Response to comments by reviewer 1

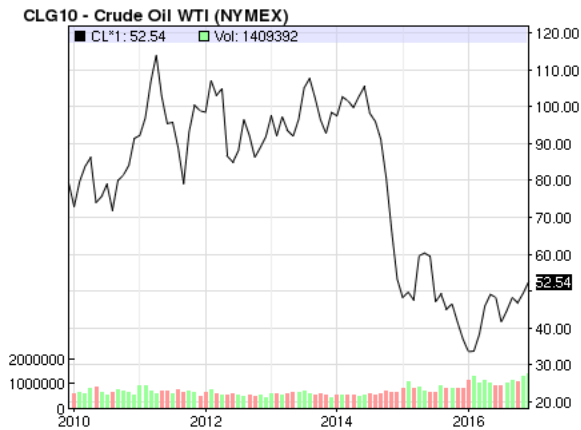
Is it possible that the drop in 550 nm AOD (Figure 5) and NAPS PM_{2.5} during 2015 is related to the fall in oil prices affecting activity in the region? If so, it may be worthwhile to note, as this would likely continue to the present day.

It is possible, but not likely, and this is too speculative in our opinion given that NAPS PM_{2.5} data is not significantly different in 2013 and 2015 (see figure below illustrating oil prices over the past seven years). (<http://www.nasdaq.com/markets/crude-oil.aspx?timeframe=7y>).
